TROPICAL WIND, ENERGY CONVERSION, REFERENCE LEVEL EXPERIMENT (TWERLE)

Status Report (for Period Ending 31 December 1973)

Transmitter--Preproduction Units

STABLE OSCILLATOR--PRE-PRODUCTION UNIT EVALUATION1. General

Modification for Mounting the Oscillator Terminal Strip.

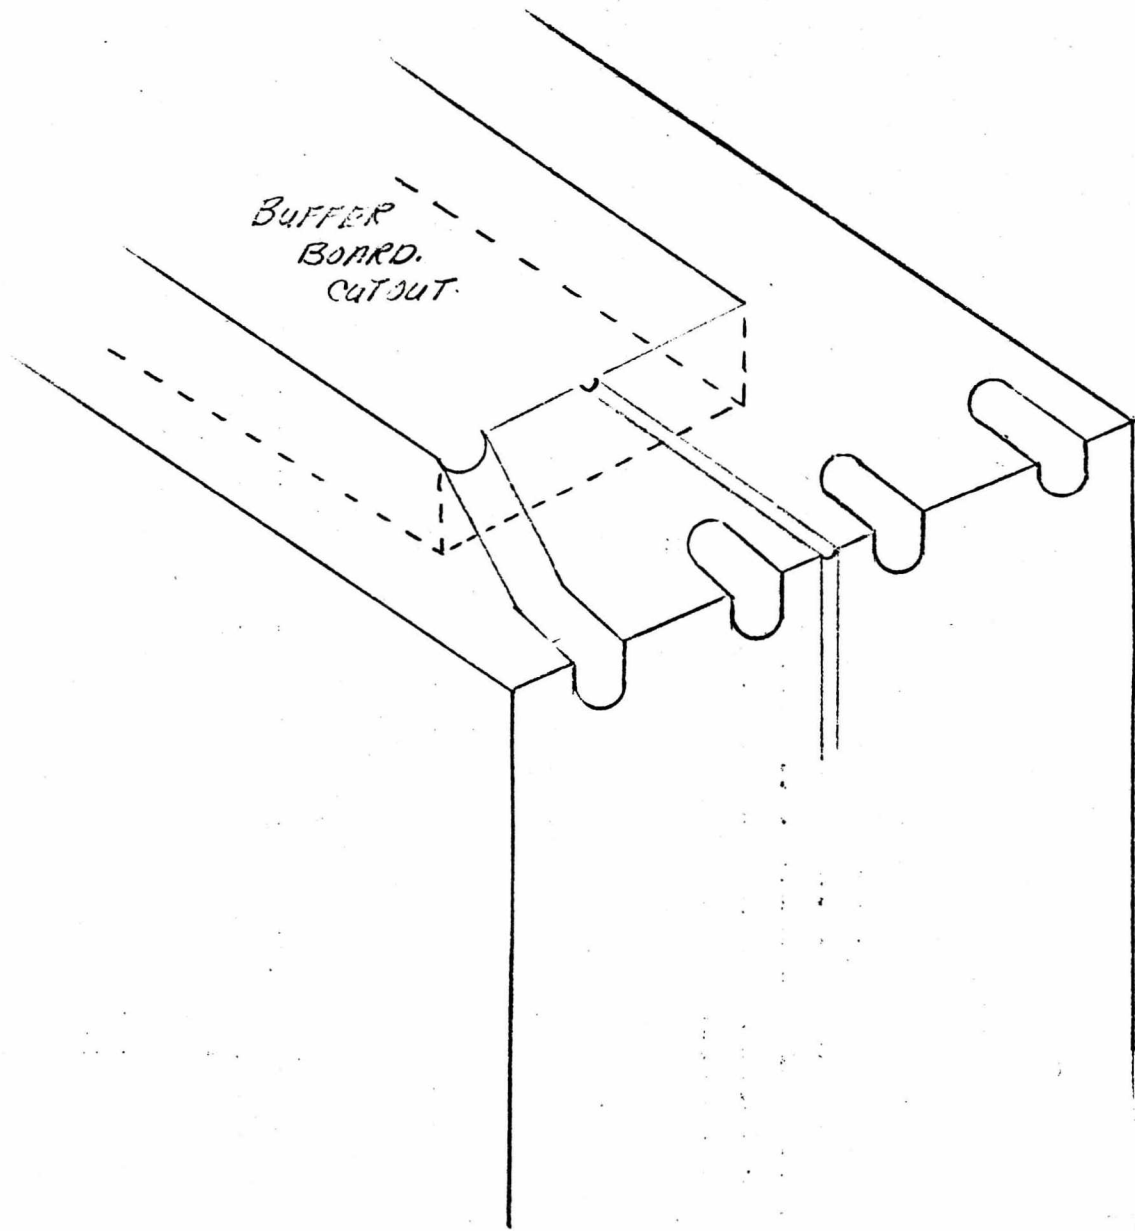
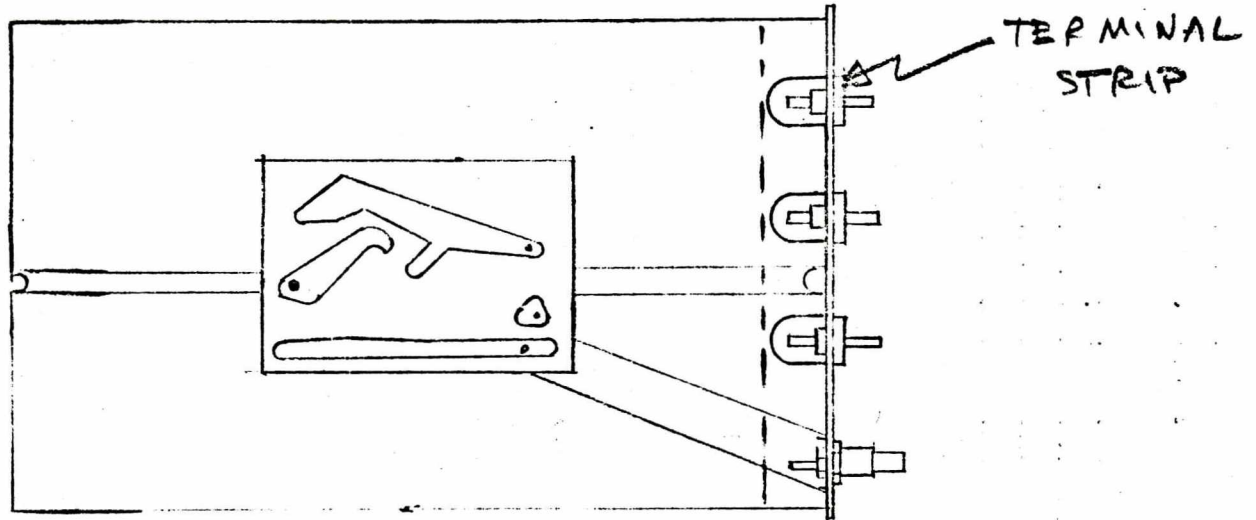
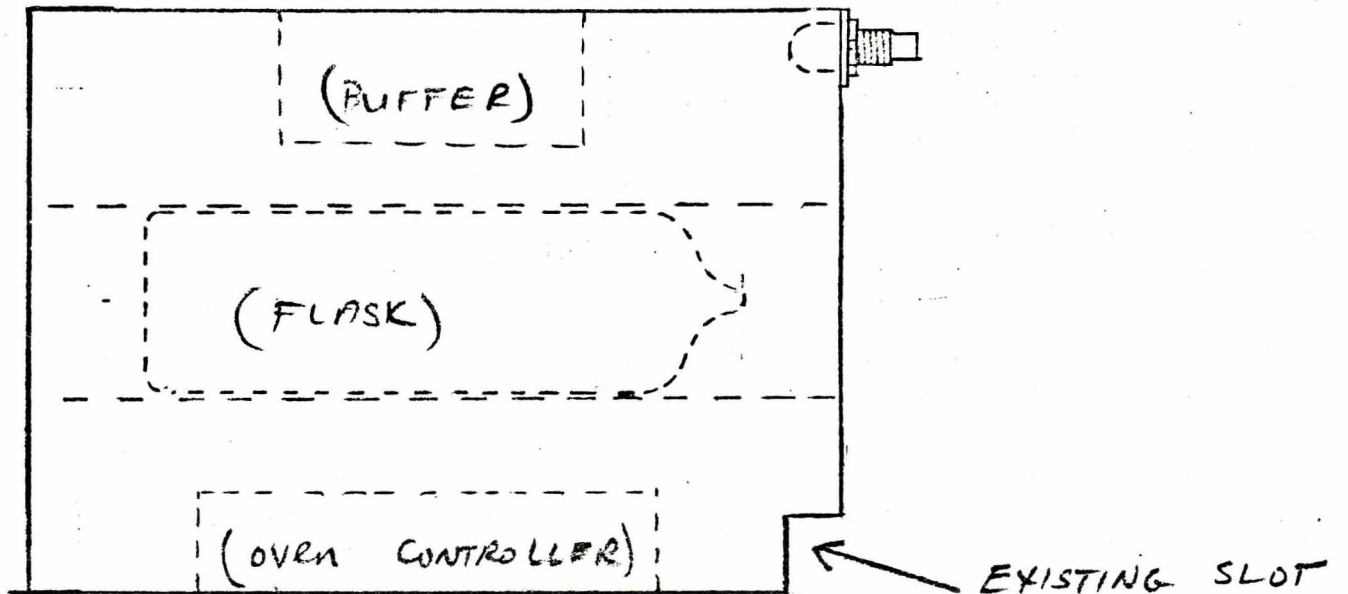
c. The channel cut for the terminal strip is too deep. Instead of cutting a complete channel it is better to make 4 slots for the three feedthrus and the RF connector. Appendix 1 describes the modification.

The scheme presently used to mount the oscillator terminal strip is awkward to implement and produces a weak mounting structure. The scheme presented below produces a sturdy mounting with little or no additional effort. Briefly, the new scheme uses slots melted in with a miniature soldering iron to mount the terminal strip. The slots are located on the buffer side of the virgin end of the inner styrofoam block (see attached drawings).

The slots for the RF connector and the power terminals are melted into the foam using the jig to be provided and a miniature soldering iron (we use a 15-watt ANTEX iron). The wire channel for the coax is melted in with the iron also. The whole process of slot melting and wire channel forming takes only a few seconds.

The terminal strip, with wires and coax attached is positioned so that the terminals and RF connector fit into the slots. When the outer styrofoam shell is assembled, the terminal strip sits flush with the styrofoam edge of the box and has excellent support.

After the foil is folded over the styrofoam (use scotch tape to fasten down flaps), the RF ground connection is made at the RF connector by tightening the RF connector nut and star washer onto the foil, thus clamping the foil to the phosphor bronze strip below. The foil, at the power terminals, is kept from shifting by taping down with pieces of scotch tape which have holes punched out to clear the solder post of the terminals. Shrink tubing should be used on the soldered terminals so that the connection has protection from the environment and so that the power supply wires are strain relieved.

Glue such as RTV, Loctite, etc., should be used liberally to secure the RF connector. The steep pitch of the thread makes these connectors prone to loosening by vibration.
